**Ontario Energy
Board**
P.O. Box 2319
27th. Floor
2300 Yonge Street
Toronto ON M4P 1E4
Telephone: 416- 481-1967
Facsimile: 416- 440-7656
Toll free: 1-888-632-6273

**Re: Canadian Niagara Power Inc.
Application for Rates
Board File Number EB-2016-0061**

Ontario Energy Board Staff Interrogatories
2017 Electricity Distribution Rate Application
Canadian Niagara Power Inc. ("CNPI")
EB-2016-0061
September 23, 2016

Ref: E2/Appendix M – CNPI Distribution Asset Management Plan (DAMP) – Section 9.2.1: Distribution System Level Analysis, Table 26: CNPI-Reliability Indices for years 2011-2015; Figure 36: CNPI Historical SAIDI; Figure 37: CNPI Historical SAIFI, pg. 105-106 of 113

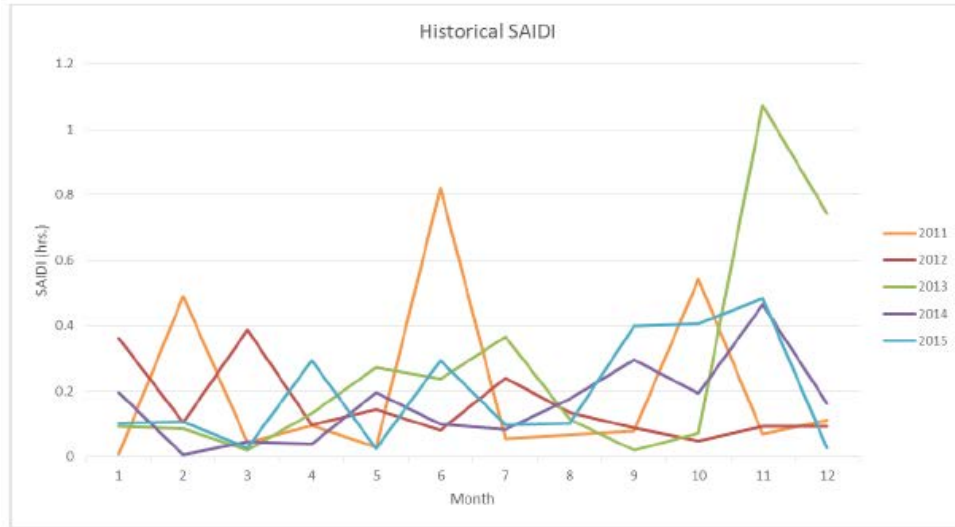
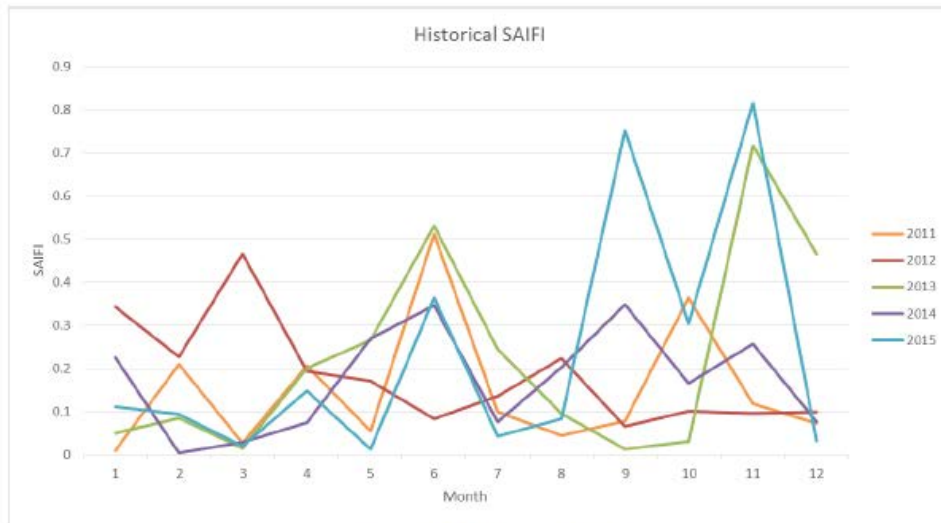
Table 26, Figures 36, and Figure 37 above display historical SAIDI and SAIFI data for the 5-year time period 2011-2015 for all outages that occurred on CNPI's distribution system. Please provide revised tables and figures displaying historical SAIDI and SAIFI separately for Fort Erie, Port Colborne and Gananoque.

Ref: E2/Appendix M – CNPI Distribution Asset Management Plan (DAMP) – Section 9.2.2: Feeder Level Analysis – Fort Erie, Figure 40: Fort Erie SAIDI for 2015 by Feeder (F-SAIDI); and Figure 41: Fort Erie SAIFI for 2015 by Feeder (F-SAIFI), pg. 110 of 113

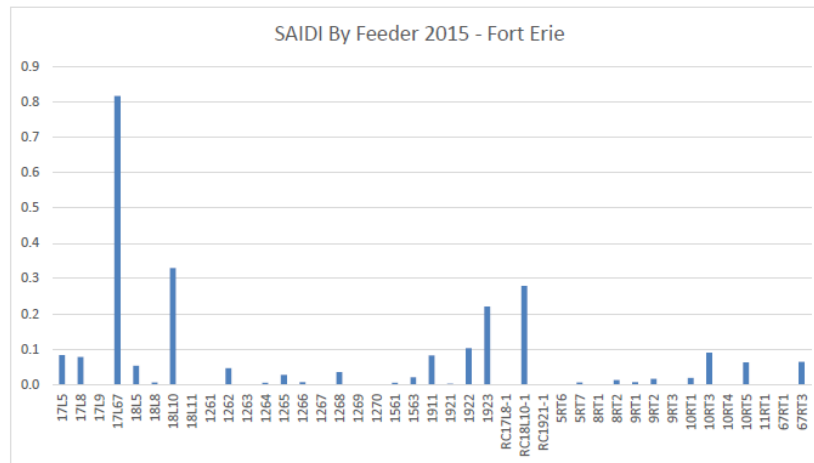
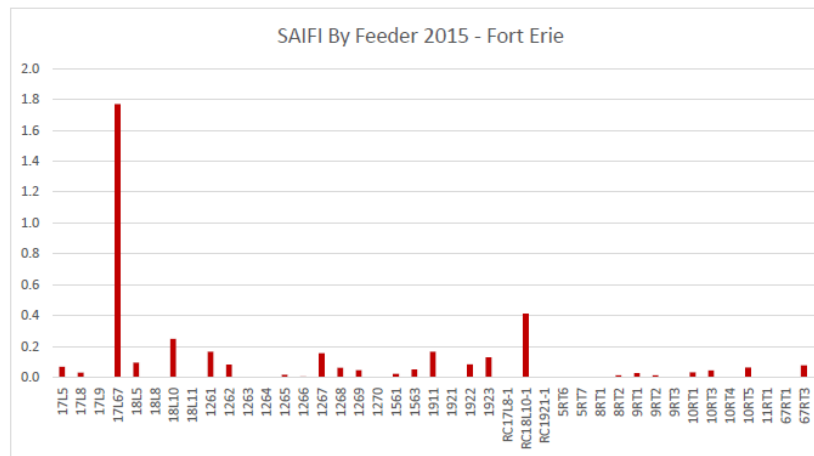
- Please state which of the Fort Erie feeders listed above are delta system feeders.
- Please explain the reasons for the comparatively high SAIDI and SAIFI indexes for feeder 17L67.
- Please identify specific actions being taken to improve performance of this feeder.

Ref: E2/Appendix M – CNPI Distribution Asset Management Plan (DAMP) – Section 9.2.2: Feeder Level Analysis – Port Colborne, Figure 42: Port Colborne SAIDI for 2015 by Feeder (F-SAIDI); and Figure 43: Port Colborne SAIFI for 2015 by Feeder (F-SAIFI), pg. 111 of 113

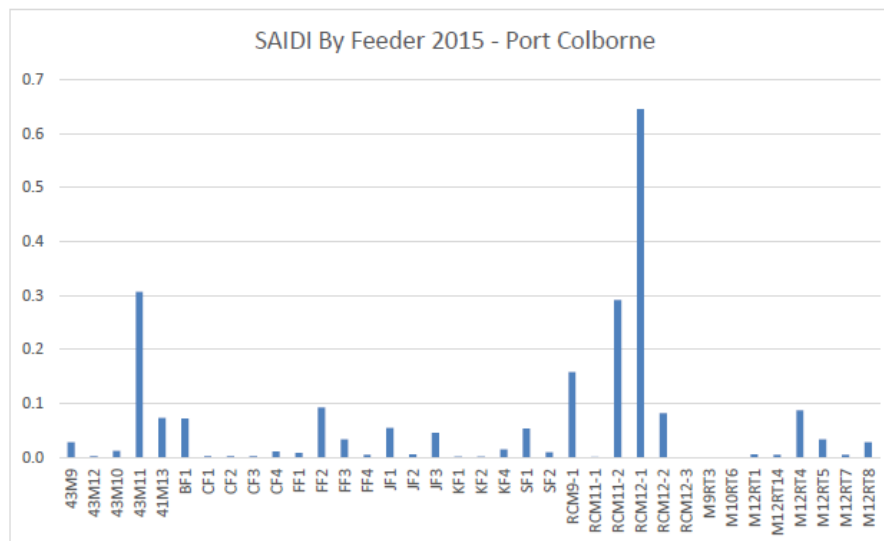
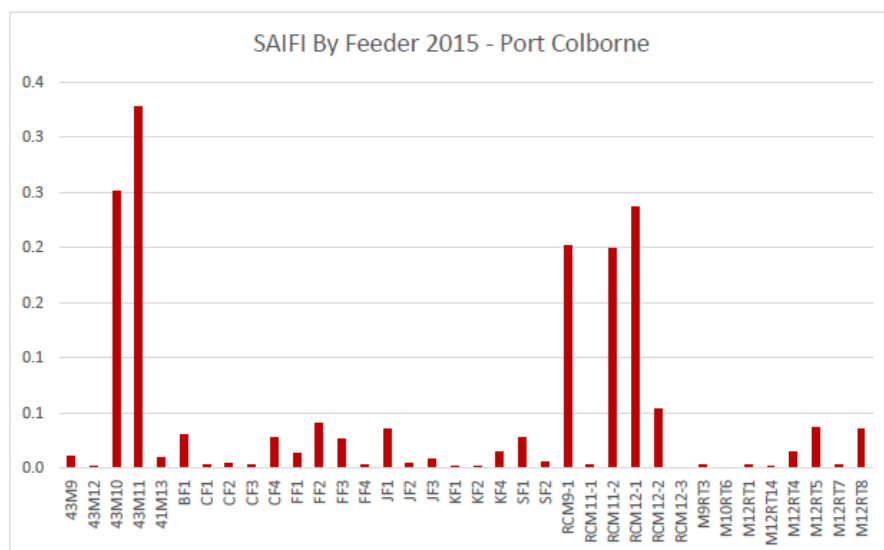
- Please state which of the Port Colborne feeders listed above are delta system feeders.
- Please explain the reasons for the comparatively high SAIDI and SAIFI indexes for the following feeders:
 - 43M10
 - 43M11
 - RCM9-1

Ref: E2/Appendix M – CNPI Distribution Asset Management Plan (DAMP) – Section 9.2.2: Feeder Level Analysis – Gananoque, Figure 44: Gananoque SAIDI for 2015 by Feeder (F-SAIDI); and Figure 43: Gananoque SAIFI for 2015 by Feeder (F-SAIFI), pg. 112 of 113

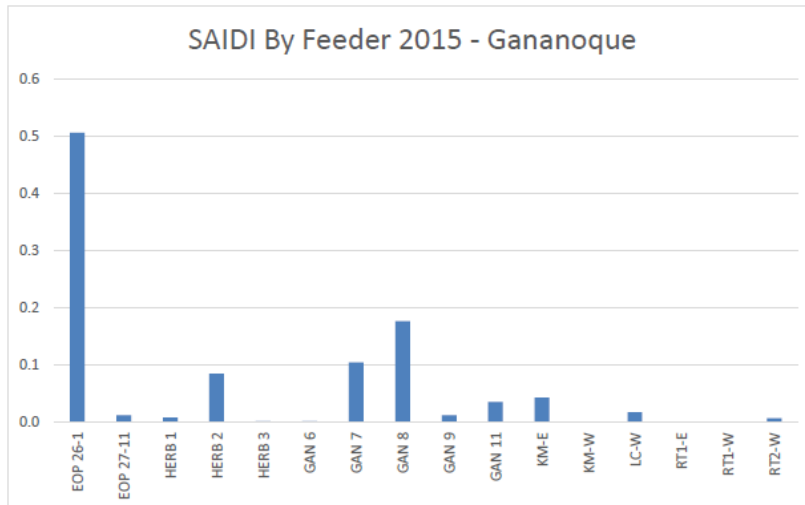
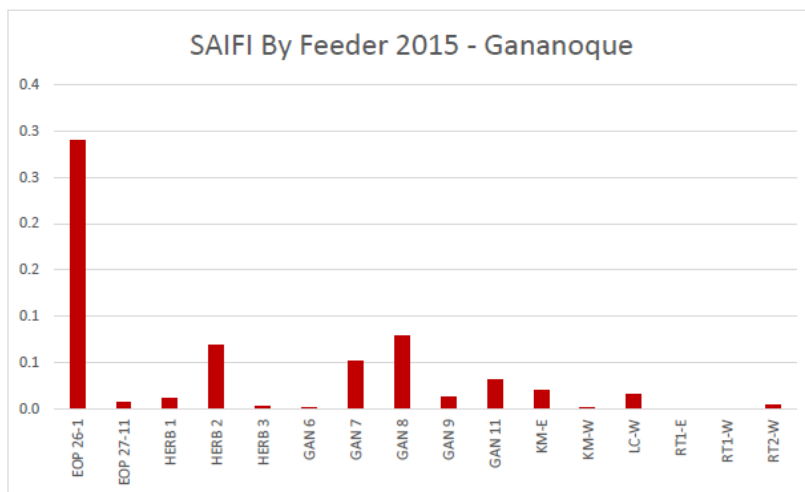
- Please state which of the Gananoque feeders listed above are delta system feeders.
- Please explain the reasons for the comparatively high SAIDI and SAIFI indexes for feeder EOP 26-1.
- Please identify specific actions being taken to improve performance of these feeders.
